ORDER NO. PTD1912X39PE

Parts Change Notice

Model No. EY46A2 <Correction for S/M PTD1408X40CE>

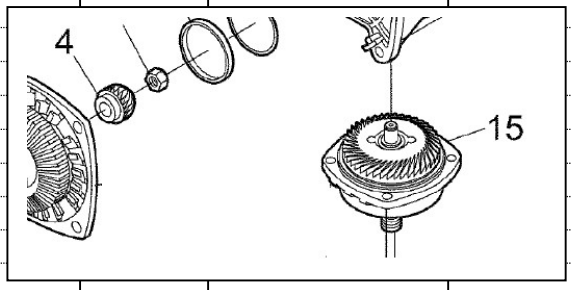
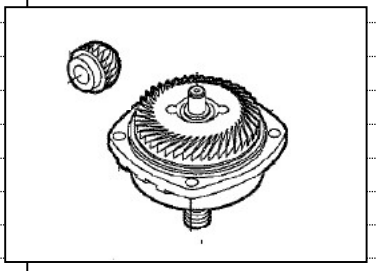
Model No.	Ref. No.	Original Part No.	New Part No.	Notes(*,**)	Part Name & Descriptions
EY46A2	4	WEY46A1L1457		*8, **E	PINION GEAR
EY46A2	15	WEY46A2K1778		*8, **E	GEAR CASE COVER ASSEMBLY
		⇩			
		WEY46A2K1701			PINION AND GEAR CASE COVER ASSEMBLY

We changed the company that processes the above two parts, so abnormal noise may be generated when new service parts are connected to the existing parts. As a countermeasure, we provide a pinion gear and a gear case assembly together as a set. Therefore, to order a pinion gear or/and gear case assembly, be sure to indicate the part No. of the parts set. (Pinion gear and gear case assembly are no longer supplied individually.)
